# AMENDMENT

ETS 300 019-1-4 A1

This amendment A1 modifies the European Telecommunication Standard ETS 300 019-1-4 (1992)

Equipment Engineering (EE);
Environmental conditions and environmental tests for telecommunications equipment;
Part 1-4: Classification of environmental conditions
Stationary use at non-weatherprotected locations

Figure 3: Earthquake Response Spectrum.

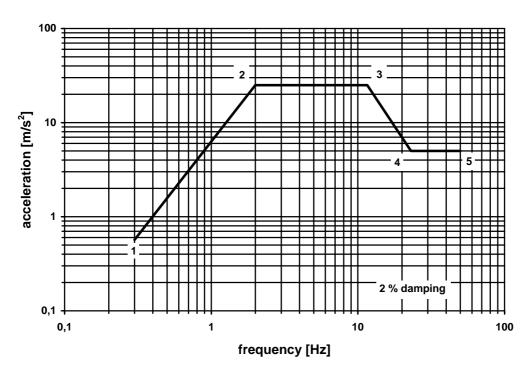
After the end of subclause 5.5, add a new subclause:

#### 5.6 Earthquake conditions

The corresponding Response Spectrum, assuming a damping ratio of the single degree-of-freedom oscillators N = 2%, is described in figure 3 and table 7.

Co-ordinate point	Frequency	Ground acceleration
	[Hz]	[m/s <sup>2</sup> ]
1	0,3	0,57
2	2,0	25
3	11,6	25
4	23,0	5
5	50,0	5
